Re:- Plot No. 20, C.L.10, Civil Lines Cr.
.....

PLAN SHOWING PROPOSED ADDITIONS & ALTERATIONS & FIRST FLOOR
ON PLOT No 20, SHEET No C/L.10 CIVIL LINES QUARTER
SCALE 8=1

With reference to your application dated 14th February 1941
with a plan for the proposed buildings/additions and alterations on plot
No 20 Survey Sheet No C.L.10, Civil Lines Quarter
I have to request you to comply with the following requirements—

With reference to your application dated _____
with a plan for the proposed buildings/additions and alterations on plot
No. 20 Survey Sheet No. C. L. 10, Civil Lines Quarter,
I have to request you to comply with the following requirements—

PLAN SHOWING PROPOSED ADDITIONS & ALTERATIONS & FIRST FLOOR
ON PLOT No 20. SHEET No C.L.10. CIVIL LINES QUARTER
SCALE 8"=1"

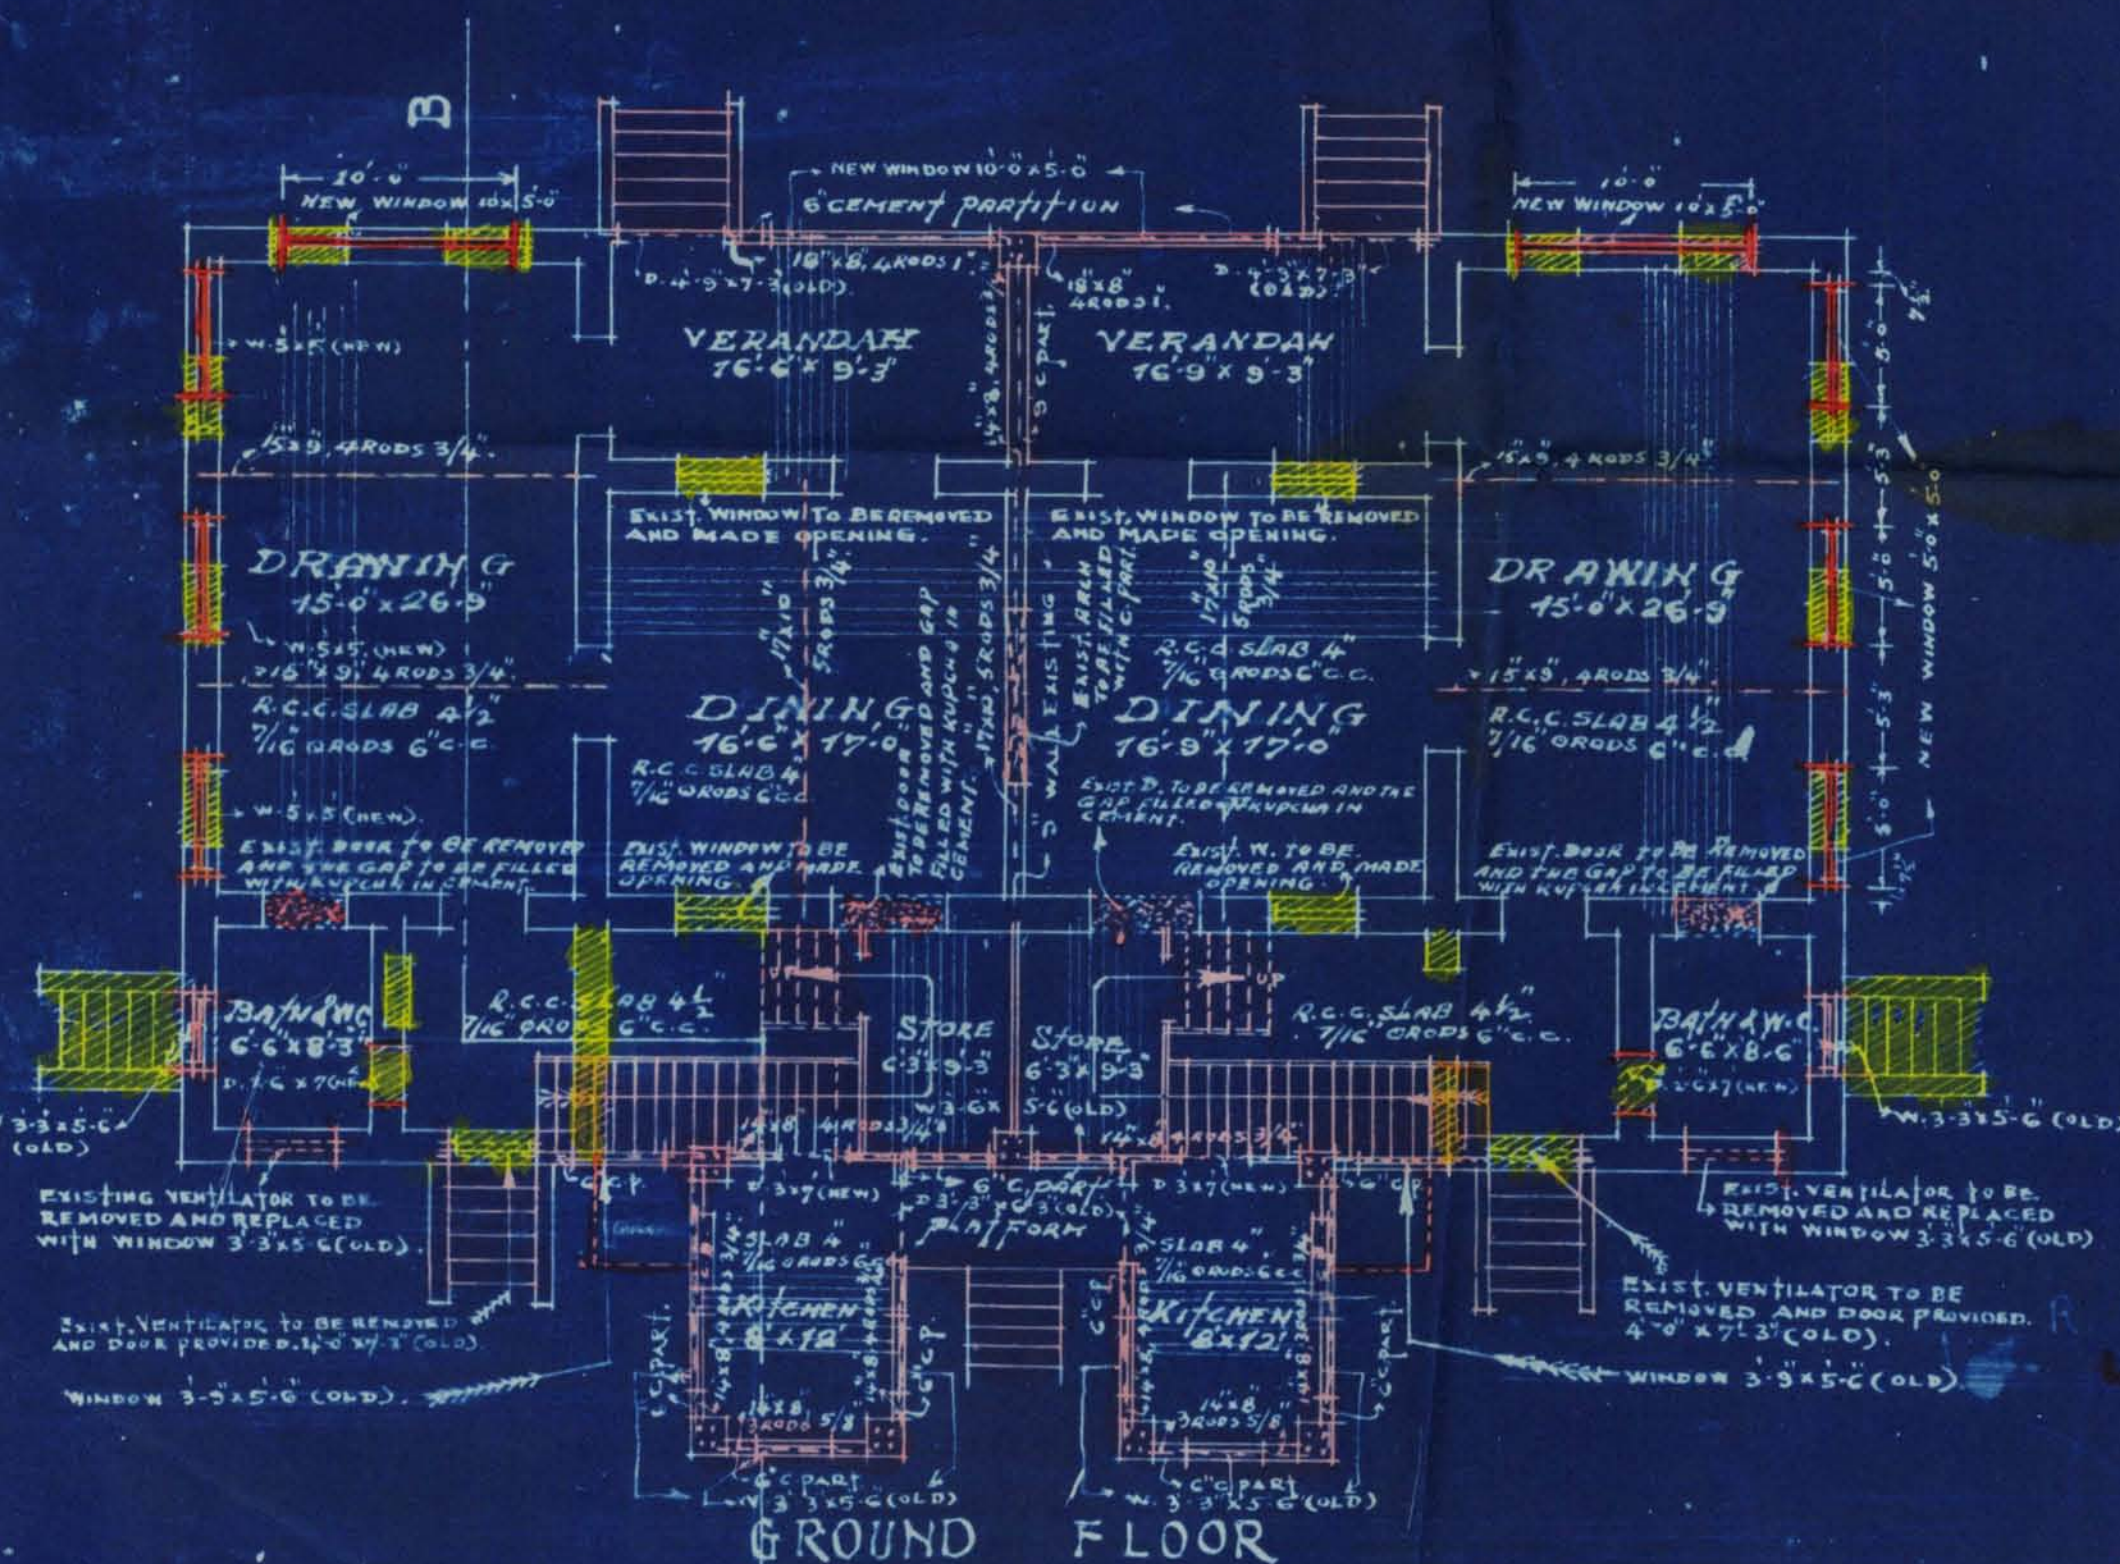
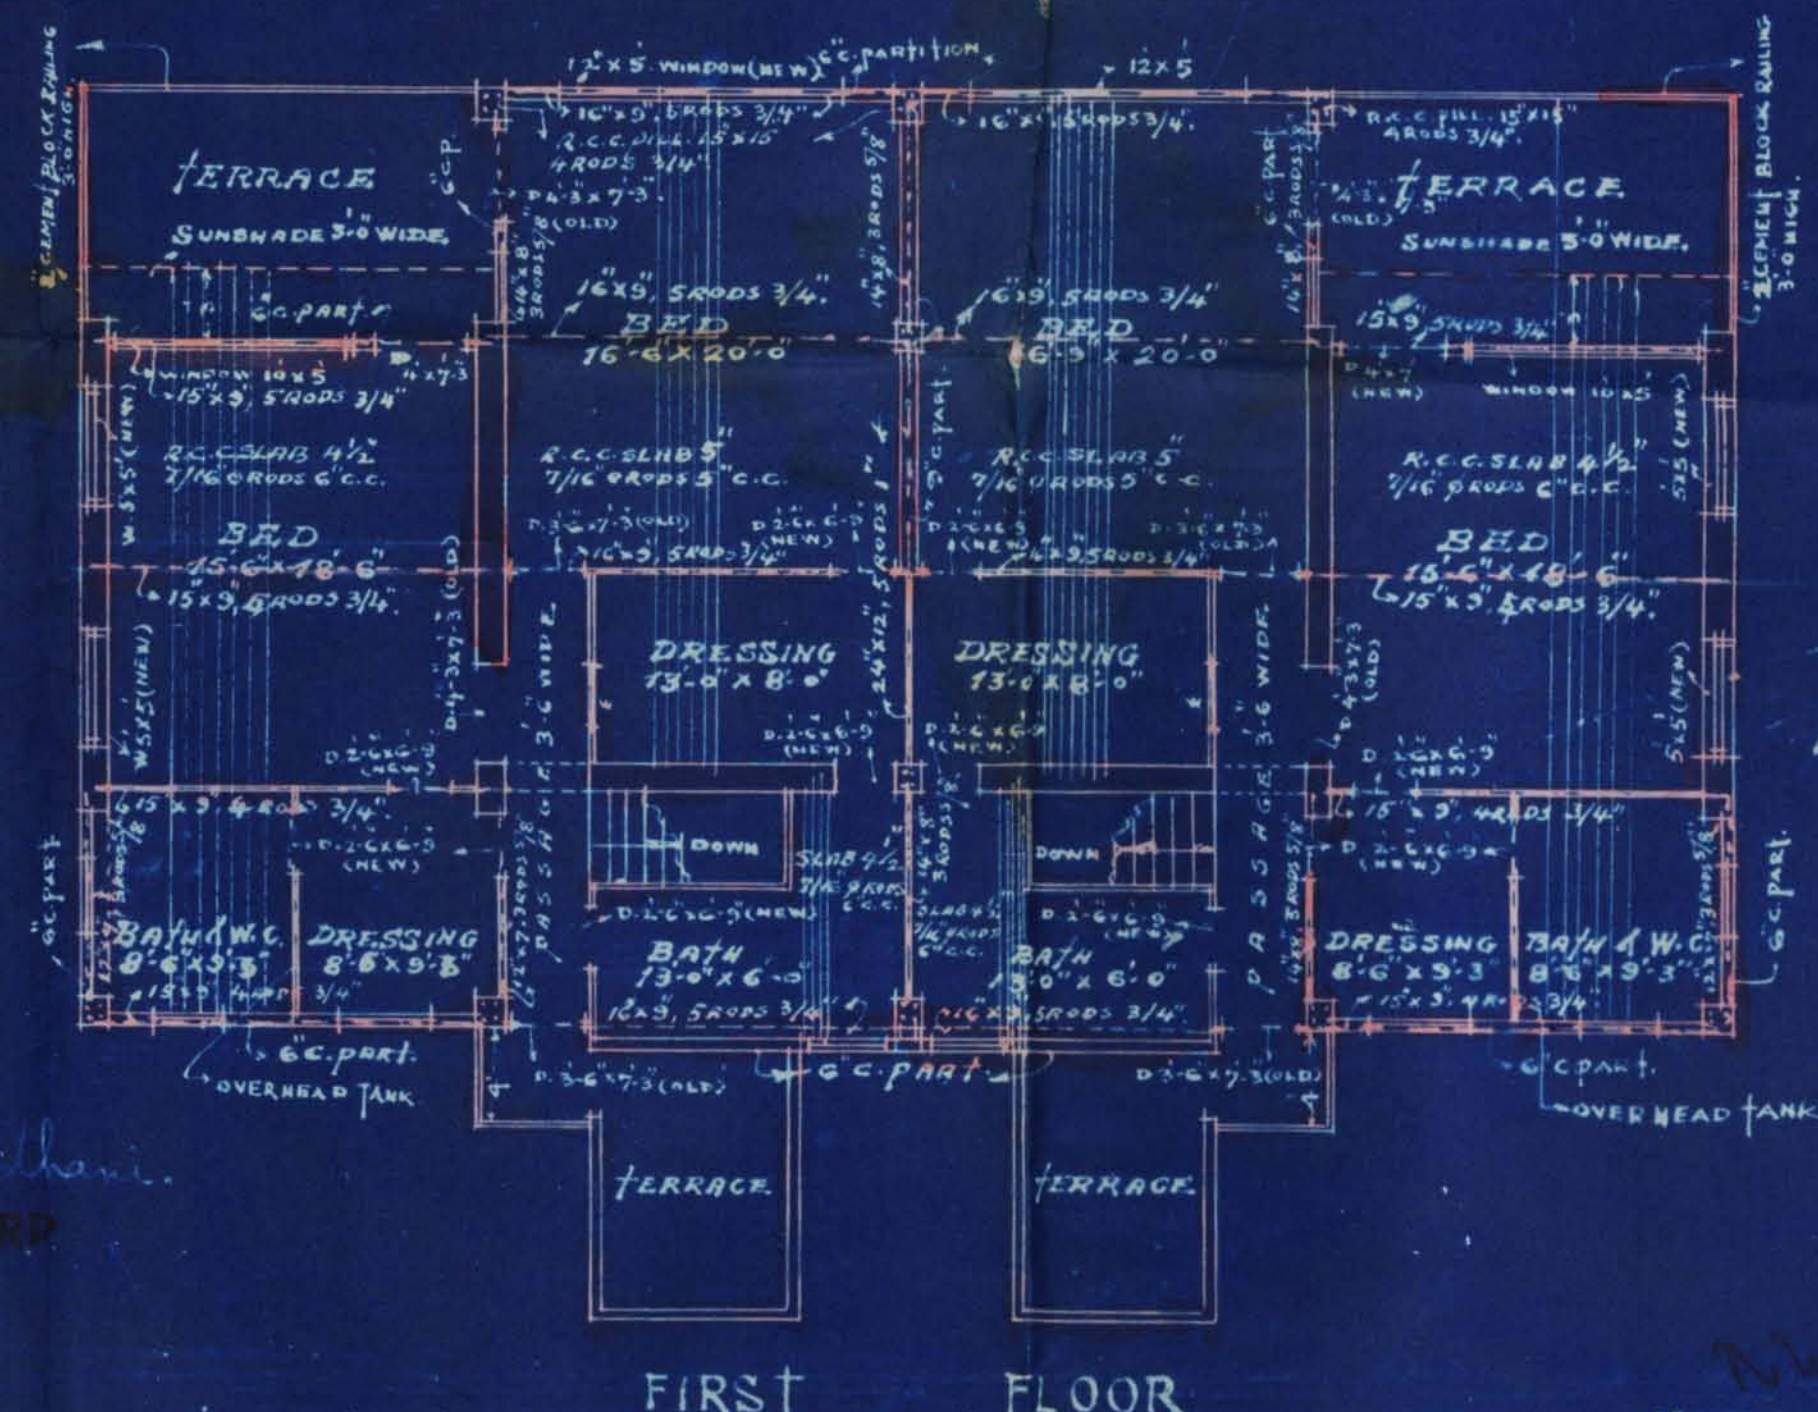
2. Complete reinforcement plan must be given
3. Some of the R.C.C details are insufficient
4. Section requires correction
5. The dimensions of foundations must be given
6. Thick walls on first floor be specified
7. R.C.C frame construction cannot be allowed on kuche walls.
8. Sun sheds must be specified on plan
9. Plinth of out houses must be made 2 ft.

- (1) Complete Reinforcement plan be given
- (2) Some of the R.C.C. details are insufficient
- (3) Section requires correction
- (4) Dimensions of foundations be given
- (5) Thick walls on first floor be specified
- (6) R.C.C. frame construction cannot be allowed over kupcha wall
- (7) Sunshades must be specified in plan
- (8) Plinth of outhouses must be made 2 ft.

L.M.A's Objections No.2 to 9 are
complied with.
